Site: CALEDON (B)

Lot: 60B

Model: GRANDVIEW (38-04) ELEV C

38-04 Grandview

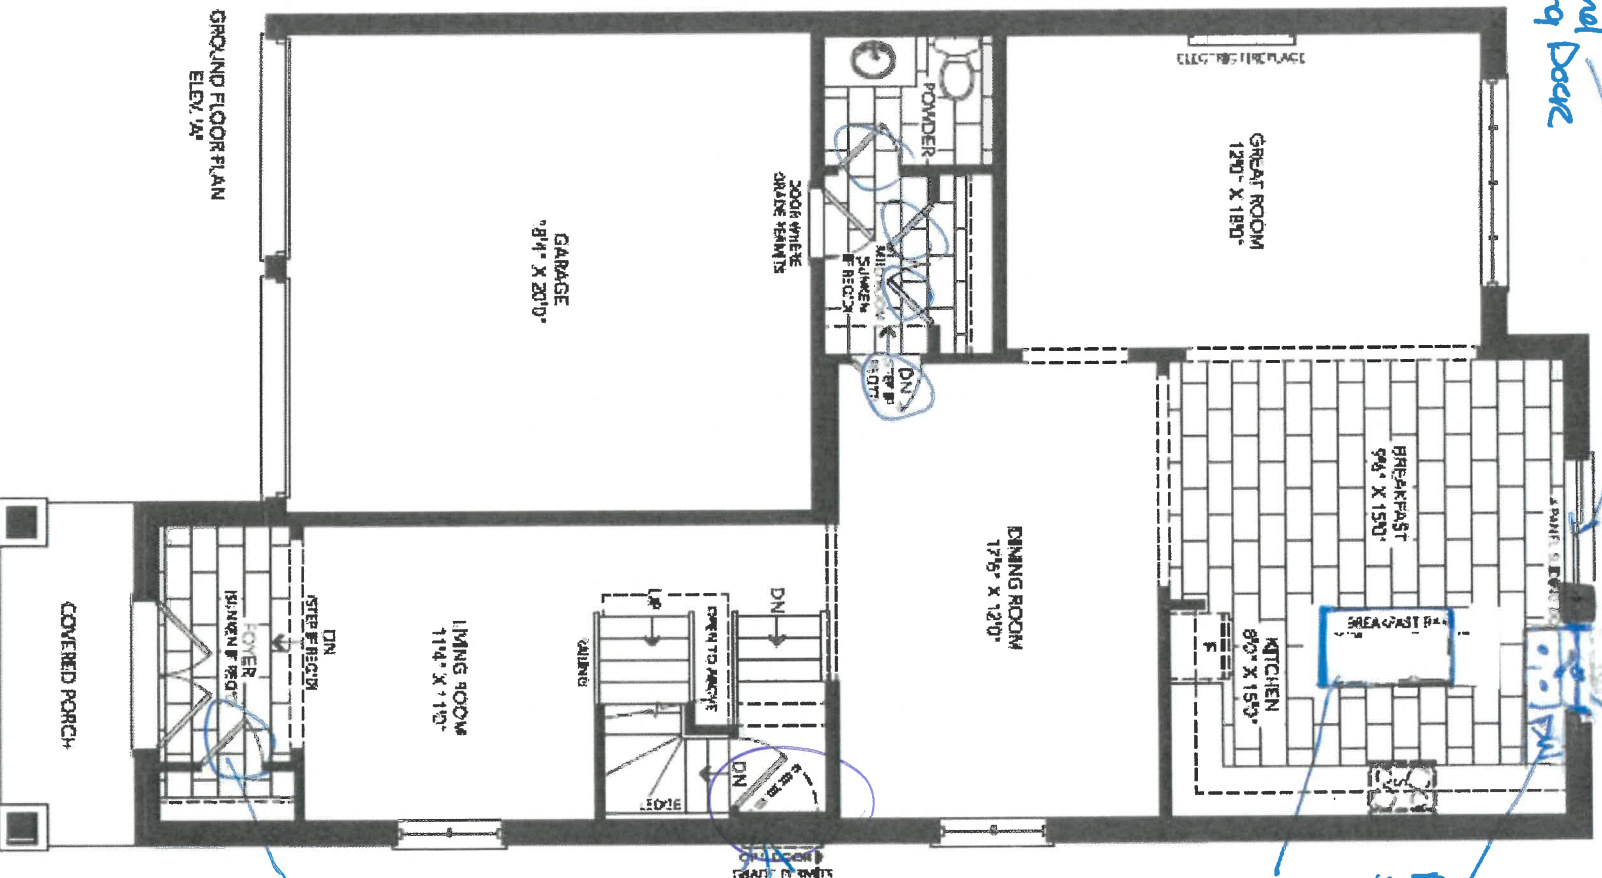
Add windows to this location approx 24' x 30" + make operable

Standard 2 panel Sliding Door

Relocate sink + Dn

Reduce island to 4' wide

Add side door entry

38-04 Grandview

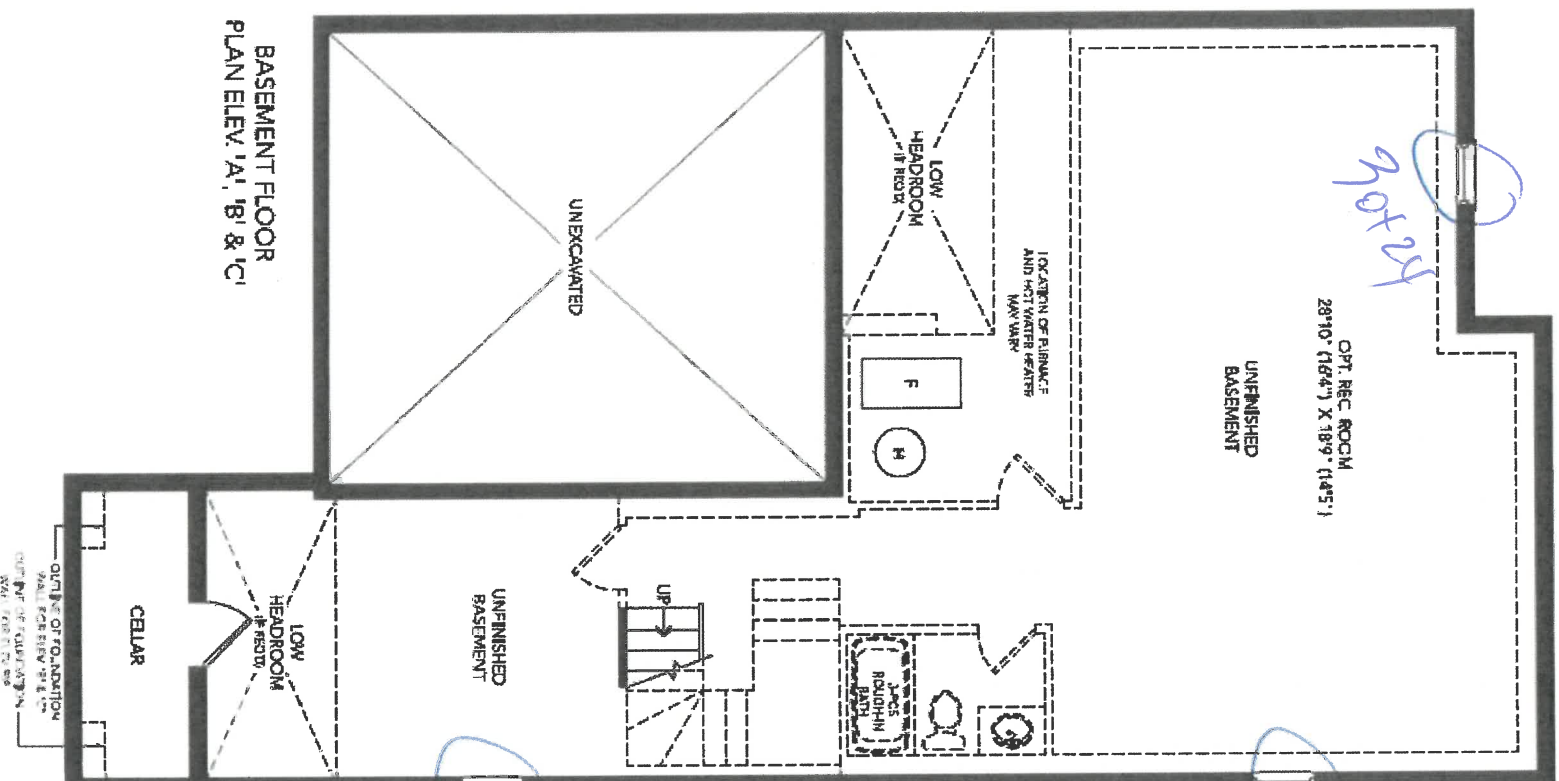
X 3
larger basement
windows
30" x 24"
Approx

30' x 24'

38-4-ELEV A,B,C
KITCHEN

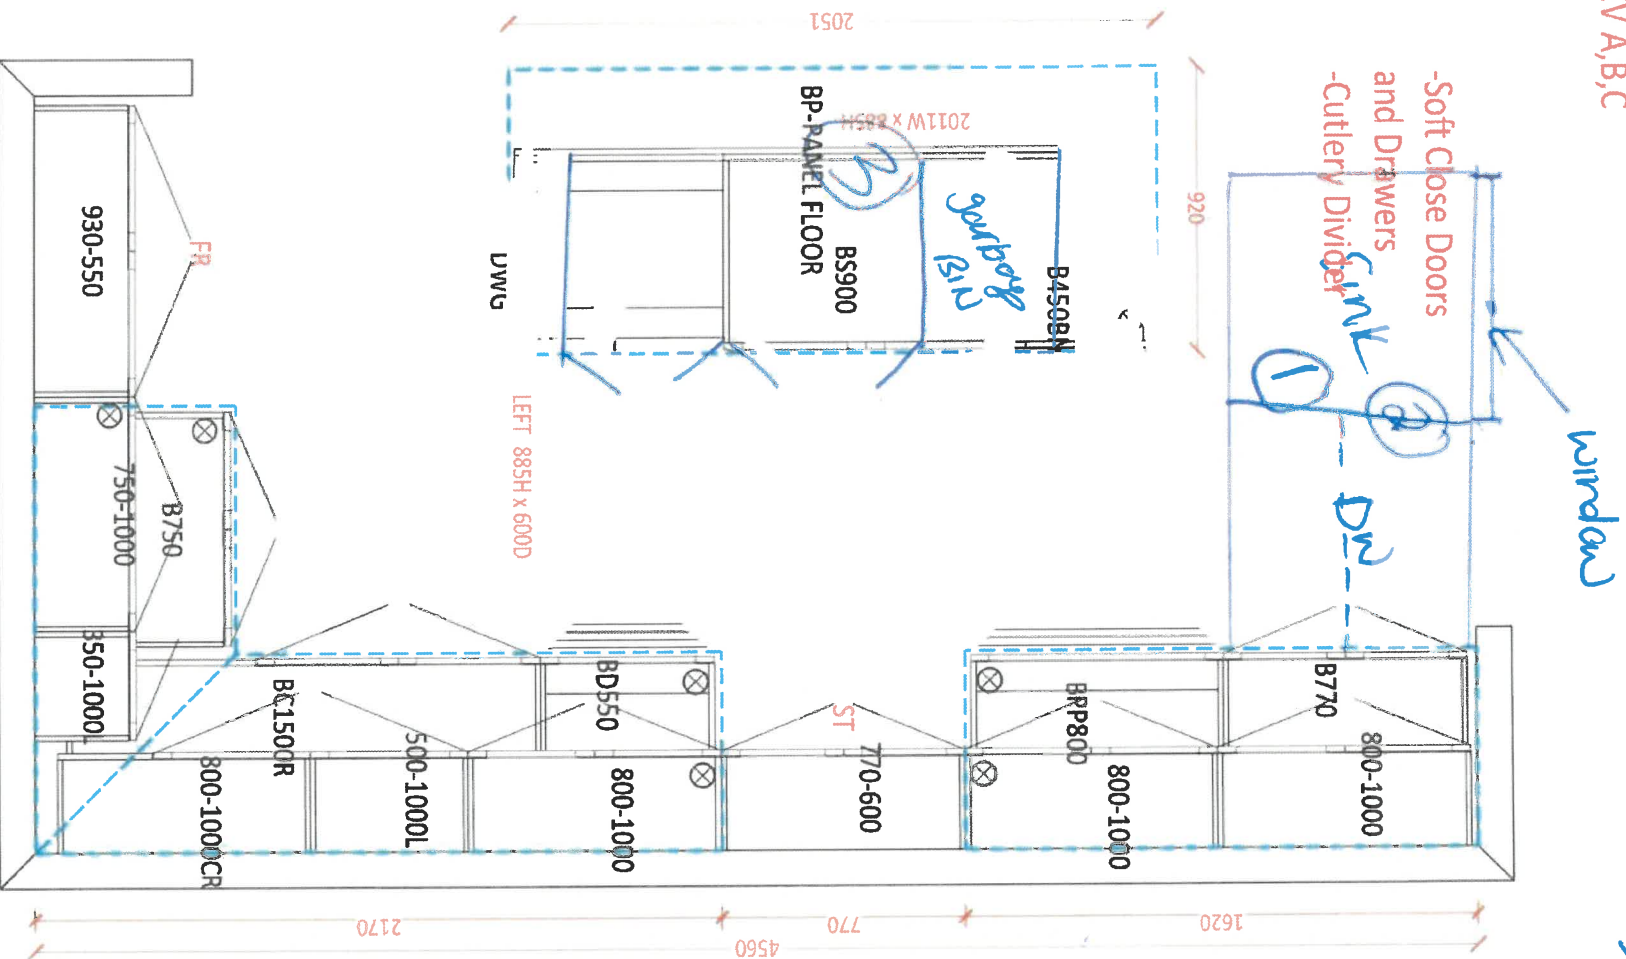
- ① Relocate Sink + Dishwasher to Rear wall
- ② Add Base cabinet under sink + uppers above Dr.
- ③ Reduce island to 4' wide
